PIC10F220/222 Rev. A Silicon Errata

The PIC10F220/222 parts you have received conform functionally to the Device Data Sheet (DS41270B), except for the anomalies described below.

FIGURE 1: TYPICAL DNL AT 2.0V (TESTING AT 7-BIT LEVEL)

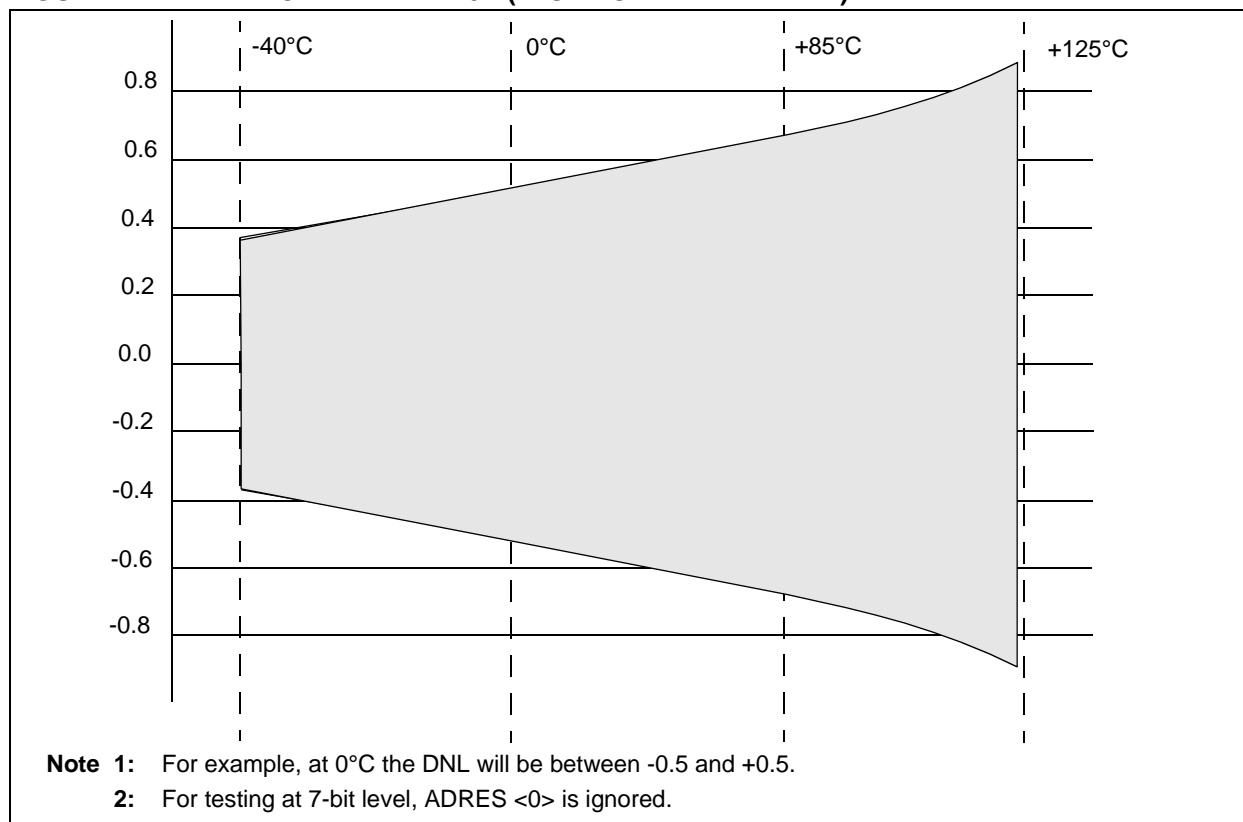
PIC10F220/222 silicon Rev. A1. The A/D Converter does not meet the design target. The specifications listed below in Table 10-6 supersede Table 10-6 in DS41270B.

Work around:

None.
